SUFFOLK COUNTY PLANNING COMMISSION

AGENDA

STAFF REPORT SECTIONS A14-14 THRU A14-25 OF THE SUFFOLK COUNTY ADMINISTRATIVE CODE

Applicant: Gull Haven Commons, LLC
Municipality: Islip
Location: s/e corner Carleton Avenue CR (17) and Sunburst Boulevard

LANDSCAPE LAYOUT, GRADING, SURFACE DRAINAGE AND MATERIALS PLAN

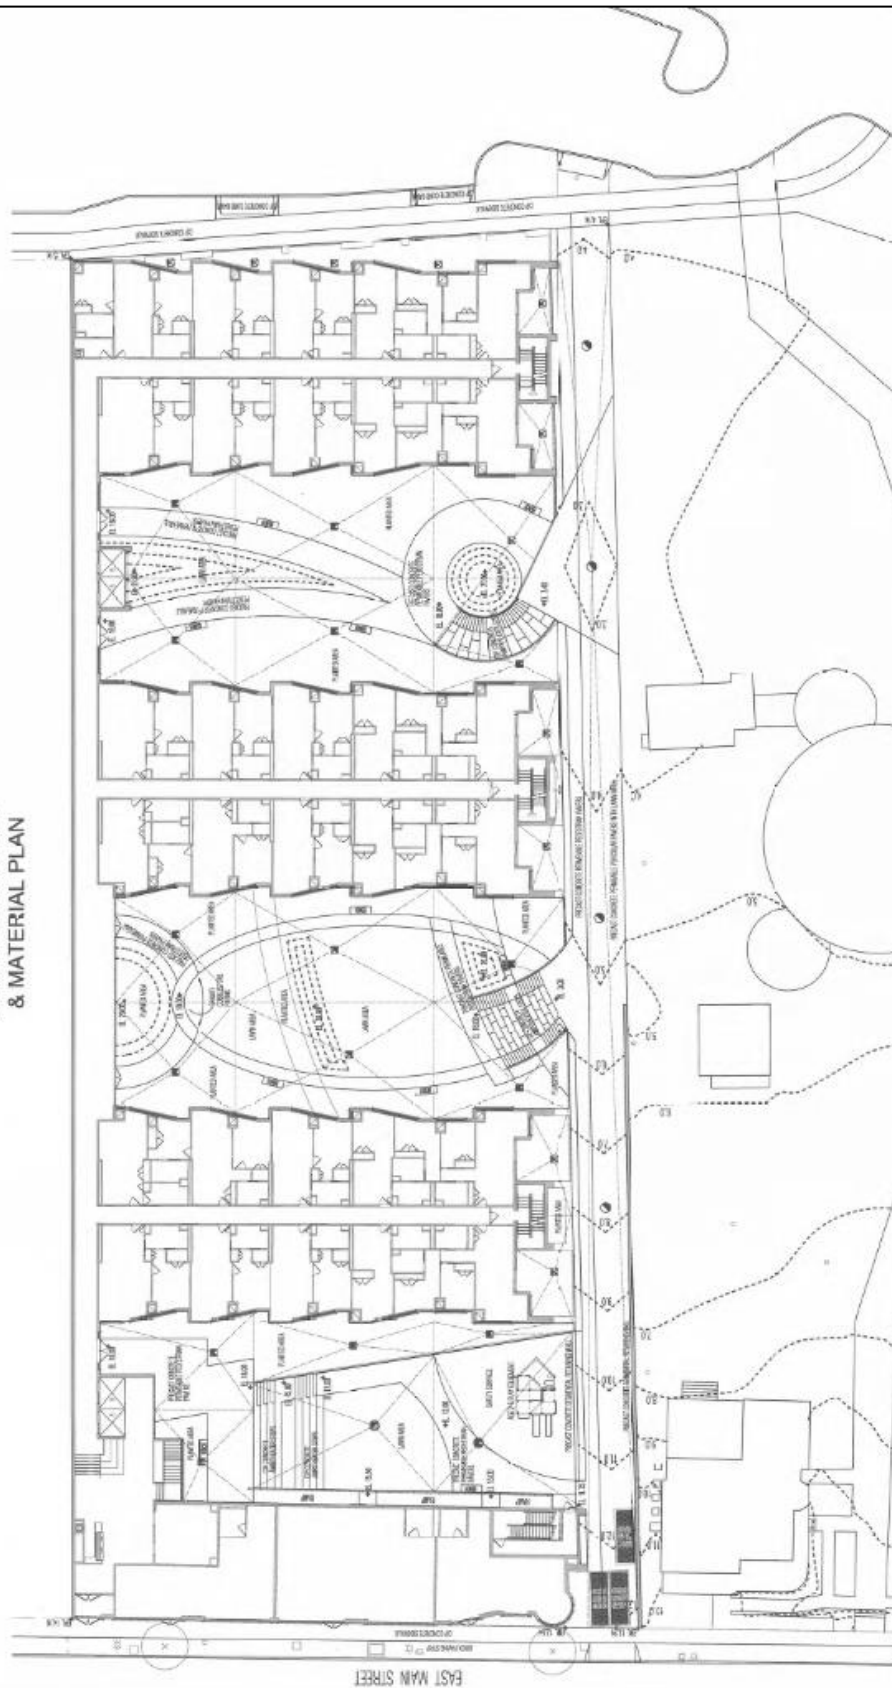
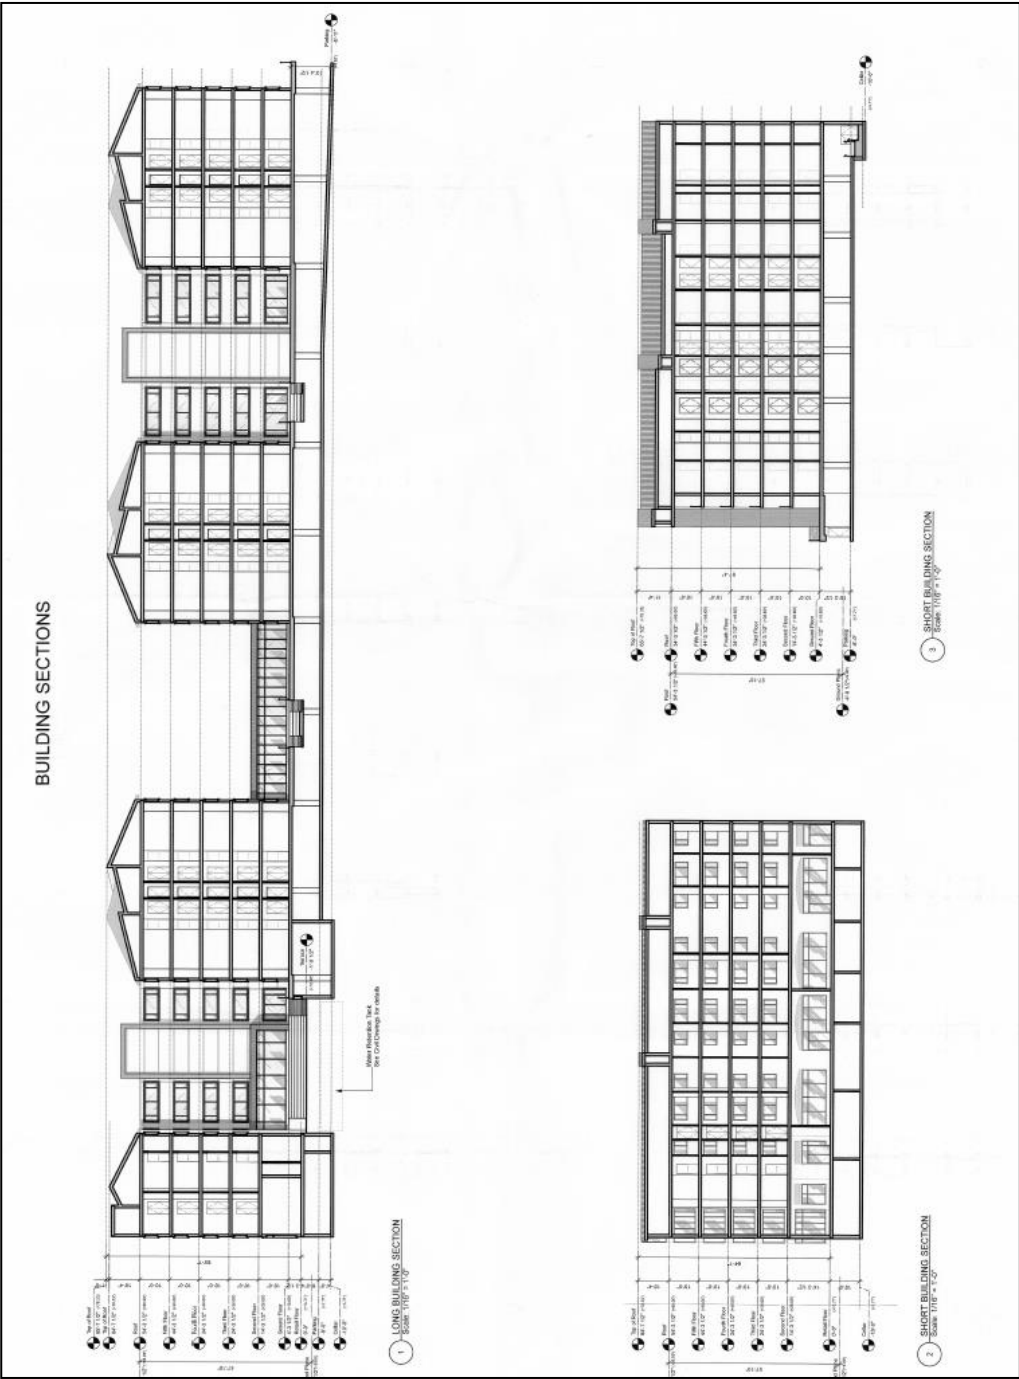
2. The Town should require the applicant to provide a Traffic Impact Study of the proposed development project in order to insure that adequate mitigation are implemented if necessary to accommodate the vehicular movement on surrounding roadways during and after the construction phases of development.

5. The applicant should be encouraged to review the Suffolk County Planning Commission publication on Managing Stormwater-Natural Vegetation and Green Methodologies and incorporate into the proposal, where practical, design elements contained therein.

7. The applicant should review the Planning Commission guidelines particularly related to public safety and incorporate into the proposal, where practical, design elements contained therein, particularly as it relates to the points where vehicles, bicycles and pedestrians will intersect. The Town should also determine whether the spacing of the proposed parking stall is safe for users.
